Re: Incorrect Thermal broken Aluminum Joinery: 2 Rapare St. Job No.27363 - JSR Construction.

The following evidence showed that your supplier does not have capability to provide the up-to-standard thermal broken aluminium windows and doors though the supplier has accepted the offer to supply you all the thermal broken aluminium windows and doors for our house at 2 Rapere Street, Rolleston 7615.

Photo 1 – Indicating the non-thermally broken parts of the Sliding Door “Lounge D6” (Door number referred to the attached quote no. 27363) (Trim Size: 2130 x 2700; Area: 5.751 m sq.)

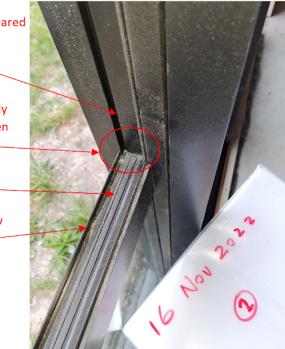
- 1) The parts of the windows and doors frames do not have the thermally broken strip. These windows and doors make up 59% of the area of all the aluminium joinery products. The total area of these problematic aluminium joinery is 28.8 m sq. The total area of all aluminium joinery products is 48.6 m sq. These problematic products are shown in the following photos (note that the photos and the location plan are given at the end of this email):

- a) Photo 1 – Indicating the non-thermally broken parts of the Sliding Door "Lounge D6" (Door number referred to the attached quote no. 27363) (Trim Size: 2130 x 2700; Area: 5.751 m sq.)

You shall provide us with all the satisfied up-to-standard thermally broken aluminium joinery. You are requested to replace and re-install all the incorrect entire windows and doors. Partly replacement of aluminium materials on the site is not acceptable. You are also liable for all our losses of cost including but not limited to the related matters of any material reinstatements, any material variations, any time delay and any opportunity costs incurred by the correction of the aluminium windows and doors. The incorrect and uncertain products are stated below with the corresponding photos and the photo location plan (Figure 1 below). The product quote no. 27363 from your subcontractor is attached for your reference.
